FINAL INCEPTION REPORT
“DESIGN AND SUPERVISION OF URBAN RESILIENCE UNIT (URU)
BUILDING INCLUDING RESEARCH, TRAINING, AND TESTING LABORATORY
FACILITIES UNDER RAJUK IN DHAKA, BANGLADESH”
(CONTRACT NO. - 1565864; PACKAGE NUMBER: URP/RAJUK/S-11)

INCEPTION REPORT

In response to questions posed by RAJUK, our response has been as indicated in RED.

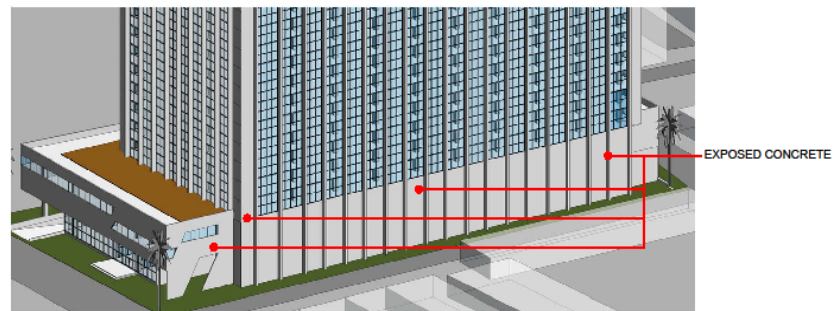
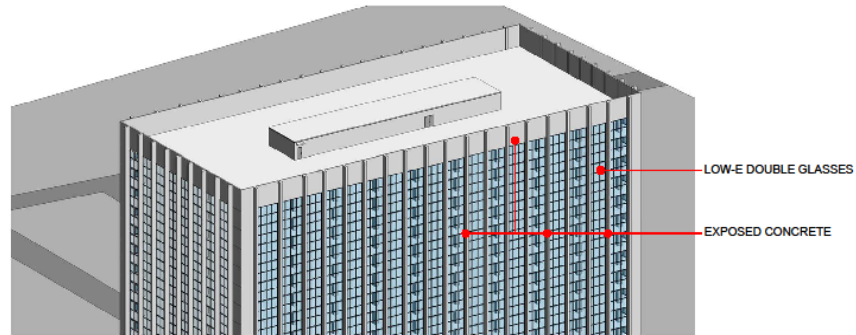
3. The site and the urban context

The site is identified in our Inception Report together with site photos and a survey plan and geotechnical study. Our instructions are to develop the site to the maximum permitted by the Authorities having jurisdiction over the site, which include 75% site coverage for the basement levels and a building podium up to 12m above grade. The office tower is to consist of 28 additional floors with an area of 50% of the site area and a floor to floor height of 3.5m thus yielding a building with a total height of 110m above grade. We are further advised that the building height limitation is 120m. Thus, an additional 2 or 3 floors could be added if RAJUK so decided.

Three specific layout options for the building on the site is depicted below:
